Virginia Electric and Power Company  
ATTN: J. H. Ferguson  
Executive Vice President-Power  
P. O. Box 26666  
Richmond, VA 23261

IE Bulletin No. 80-20

FAILURES OF WESTINGHOUSE TYPE W-2 SPRING RETURN TO NEUTRAL CONTROL SWITCHES

FIGURE 1

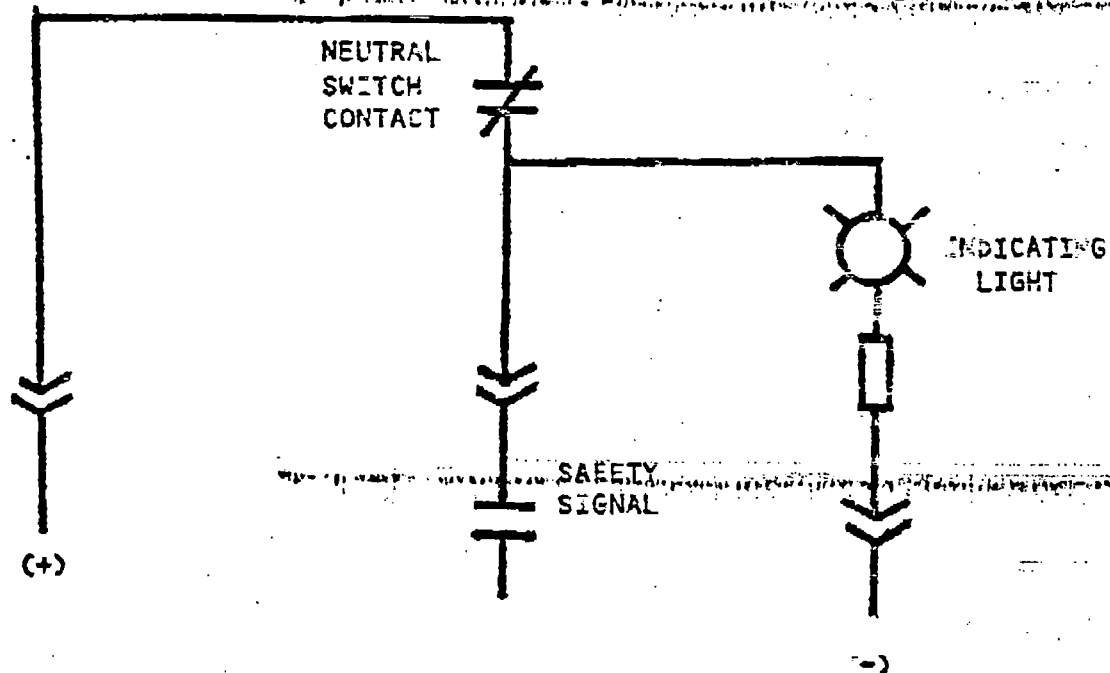
A review of this matter by Westinghouse led to the issuance of NSD Technical Bulletin No. NSD-TB-80-9 to the utility owners of all Westinghouse operating plants. The recommendations contained in the Westinghouse technical bulletin include: (i) testing the neutral position contacts of the subject W-2 switches for continuity, and (ii) rewiring of the indicating light circuit to permit the early detection of a neutral contact failure as shown in Figure 1.

Depending on how the indicating light circuit is wired, loss of continuity thru the neutral position contact of a W-2 switch could remain undetected until the equipment associated with the switch were called upon to operate. Since such a failure would be equivalent to by-passing the system associated with the switch, consideration should be given to rewiring the switches used in safety-related applications as shown in Figure 1. Such rewiring would provide an acceptable means for detecting contact failure, provided the indicating light is in the control room and readily visible by the operator. If the indicating light is not so located, consideration should be given to annunciating the neutral position contact failures at the control room to alert the operator of the inoperable status of a safety-related system. In addition, consideration should be given to adding redundant contacts to the W-2 switches or to replacing the W-2 switches with others having a more positive contact wiping action.

3. Licensees of operating plants and holders of construction permits shall describe the longer term corrective measures planned and the date by which such measures will be implemented by actual installation or by design change, as appropriate. As a minimum, the longer term corrective measures should include rewiring the indicating light as shown in Figure 1 provided the light is readily visible to the control room operator. If not, failures of the neutral position contacts should be annunciated in the control room.
